Product Change Notification

113553 - 00

Change Notification #: 113553 - 00
Change Title: Intel® Server System R1304GZ4GC
PCN 113553-00, Product Design
Update the System Rear Panel and 750W
Common Redundant Power Supply, Add a
Mylar and a Plastic Block
Date of Publication: December 29, 2014

Figure One

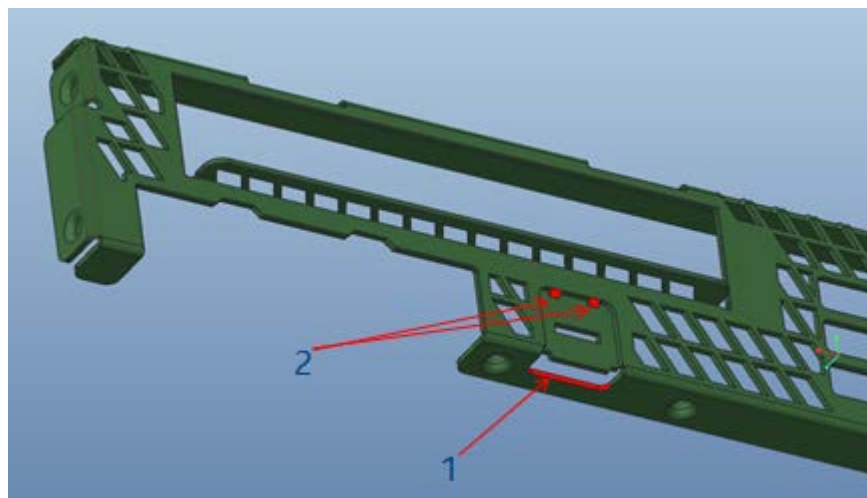
1. Add a connection at the bottom of the RMM4 (Remote Management Module 4) slot to improve structure strength. See item 1 in Figure One.
2. Update the one big center joint to two smaller joints so that the joints will not conflict with the LAN cable connector latch. See item 2 in Figure One.

Figure Three

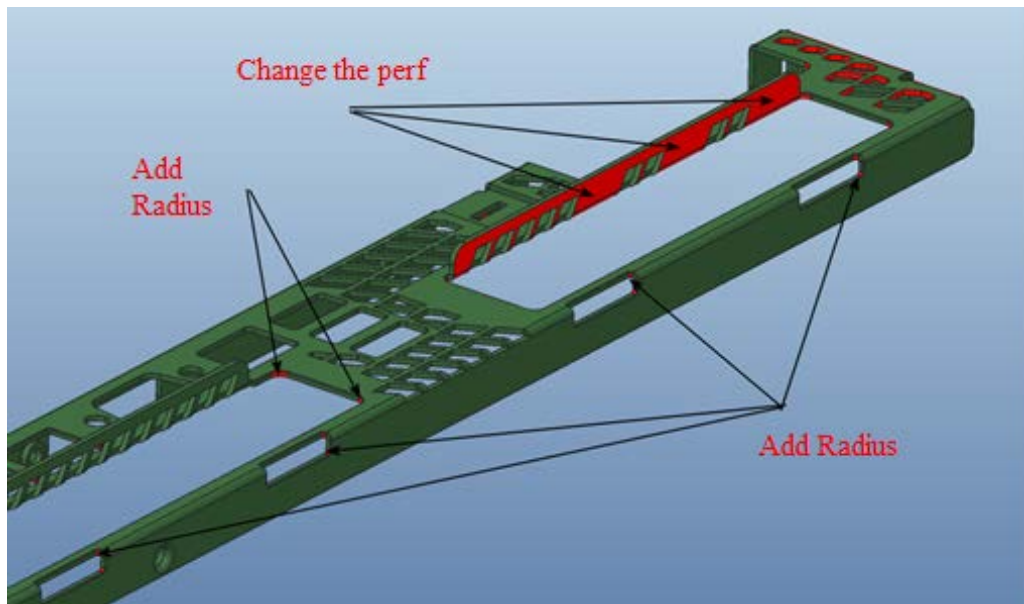
4. Update the perf and add radius to improve structure strength. See Figure Three and Figure Four.

Figure Five

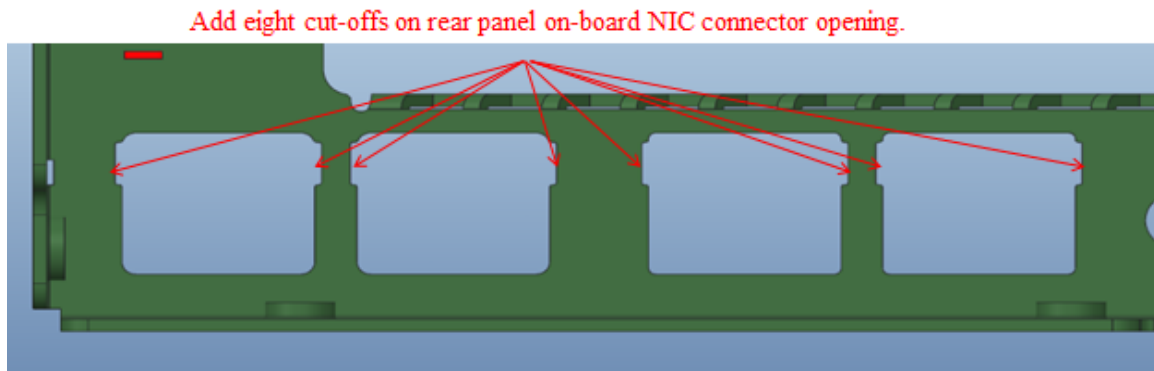
5. Add eight cut-offs around the on-board NIC (Network Interface Controller) openings to improve the LED visibility. See Figure Five.

Figure Six

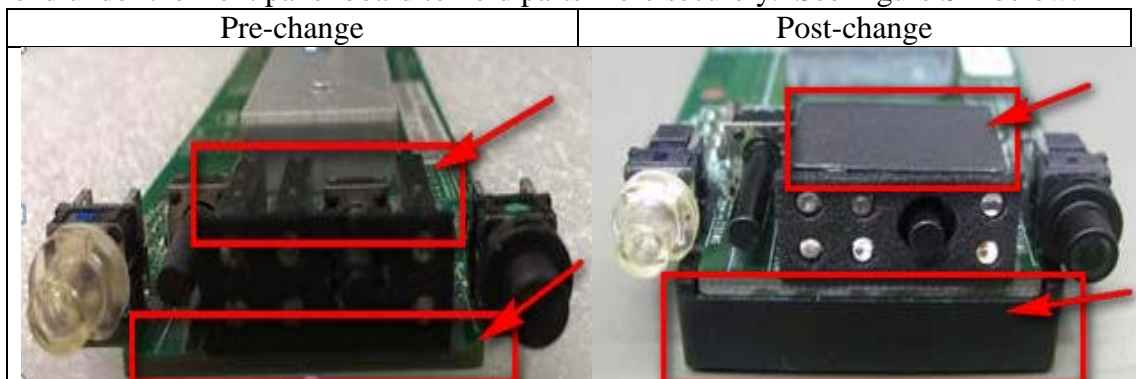
6. Add a Mylar on the top of the front panel board and add a plastic block for the front end under the front panel board to hold parts more securely. See Figure Six below:
